Pooks Hill Sketch Plan No. 320150060

Completed: 7/17/2015

Description

Figure 4 Proposed Sketch Plan

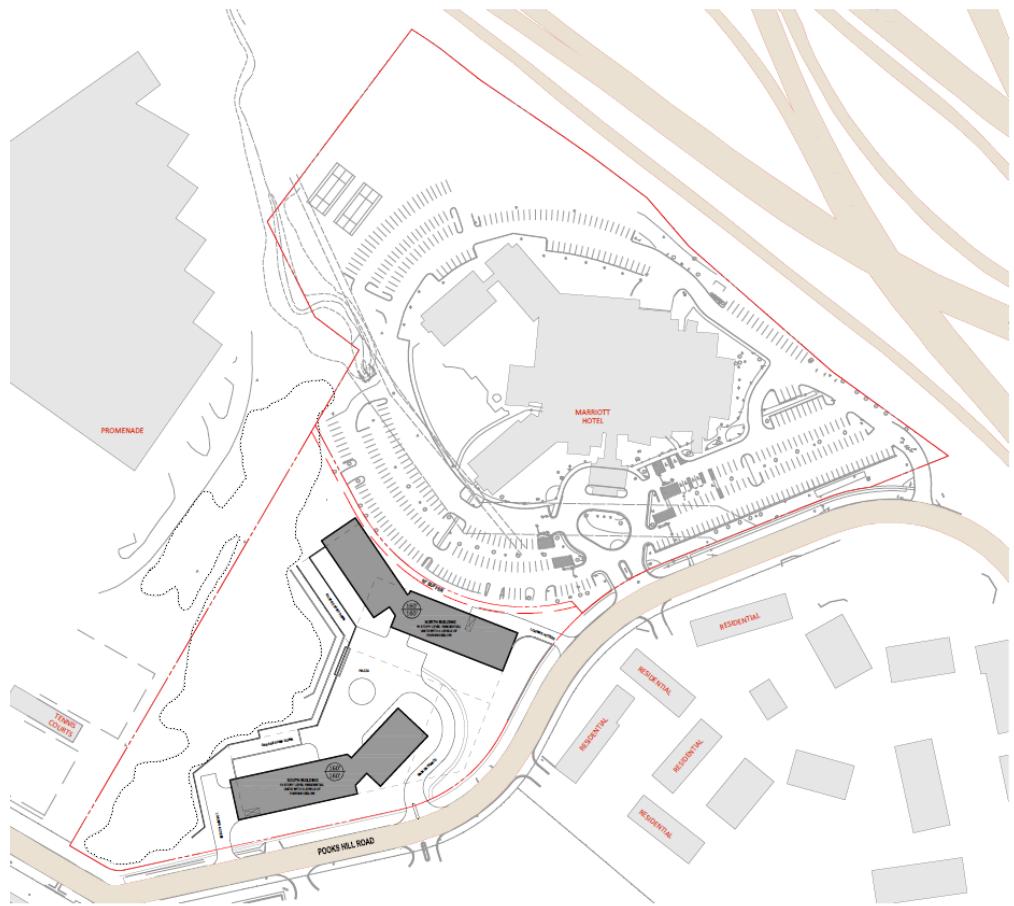
The Sketch Plan also includes the Hotel which consists of 259,593 square feet of non-residential uses and is developed as the Bethesda Marriott Hotel and Conference Center. The existing Hotel density is included as part of the non-residential component of the Application. The Property is zoned CR 1.0, C 1.0, R 0.75, H 160. Under this Application, an expansion of 35,000 square feet is proposed on the hotel site. As stated previously, the

location of this proposed square footage or the massing of the proposed structure is shown on submitted Sketch Plan. Based on these deficiencies, Staff cannot review or recommend approval of the 35,000 square foot expansion at this time.

Staff does not recommend approval of the 35,000 square foot hotel expansion at this time based on insufficient information submitted with the subject Sketch Plan Application.

Figure 8 Central Plaza Area

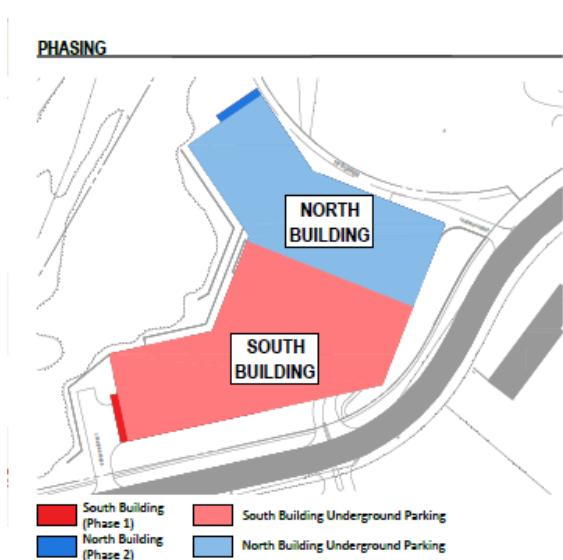
Currently, as proposed the central plaza appears to function as a more auto-centric space serving as the entry point for both garage entrances and deliveries of packages. Potential opportunities exist for this space to better accommodate pedestrians and vehicles. In the recommended development conditions, Staff identified the following issues to be resolved at Site Plan:

- g. Screen loading and service areas from Pooks Hill Road.
- h. Further develop the central plaza to:
 - i. More clearly delineate the limits of vehicular access and to define pedestrian and seating areas, through the use of bollards, paving, landscaping, lighting and similar methods.

- ii. Identify opportunities for pedestrian paths to the required Green Area.
- i. All retaining walls should be designed to provide year round visual appeal through use of materials, plantings and/or public art.
